#### REMARKS

First, the Examiner has objected to the drawings under the requirements and provisions of 37 CFR 1.83(a). More specifically, the Examiner has stated that according to the requirements of 37 CFR 1.83(a) the Figures are required to show two speed sensors immediately adjacent one another as recited in claim 2 and as described, for example, in paragraphs [022] and [032] of the specification, that the speed sensors and the distance sensor are situated in a common housing as recited in claim 23 and as described, for example, in paragraphs [021], [022] and [032] and in Fig. 1 for the implementing using a single speed sensor, and an evaluation device located in the sensor housing, as recited in claim 26, or in a separate control unit, as recited in claim 27, and as described, for example, in paragraphs [032] and [033].

Fig. 1

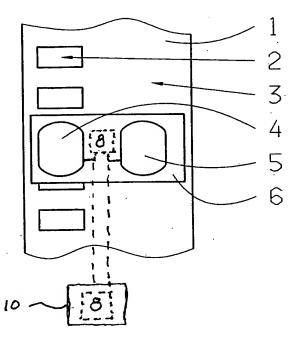
The Applicant wishes to point out that the elements in questions, that is, two adjacent speed sensors, the location of the two speed sensors in a common housing, and the location of an evaluation device located in either the sensor housing or a separate control unit are thereby fully described in the specification and claims as originally filed. In this regard, the Applicant refers to originally filed claims 2, 23, 26 and 27, or their equivalents, which are a part of the original disclosure, and, for example, paragraphs [021] [022], [032] and [033] of the specification and Fig. 1. As such, the illustration of these elements and arrangements in a Figure will not add any new matter to the present Application, but will merely operate to meet the formal requirements of 37 CFR 1.83(a) so long as no more is presented in the Figure than has been originally described in the specification and claims.

In response, therefore, the drawings are amended, per the attached Submission, to overcome the grounds for objection noted by the Examiner and new Replacement Sheets of formal drawing accompany this Submission and incorporate all of the requested drawing amendments. In particular, the Applicant has submitted and amended Fig. 1 and a new Fig. 3 wherein Fig. 1 is directed to the embodiment of the invention employing a single speed sensor 4 while Fig. 3 is directed to an embodiment employing two adjacently located speed sensors 4, which are designated by the reference numbers 4A and 4B. The amended Fig. 1 and the new

Fig. 3 also show an evaluation device 8 located in either the sensor housing 6 or a separate control unit 10. In this regard, it must be noted that the common housing recited in claim 23 and the sensor housing recited in claim 26 are not different elements, but are both, in fact, the sensor housing 6 shown in Fig. 1 and described in paragraph [032] and [021] and that the use of the term "common housing" in place of "sensor housing" is merely an error in nomenclature.
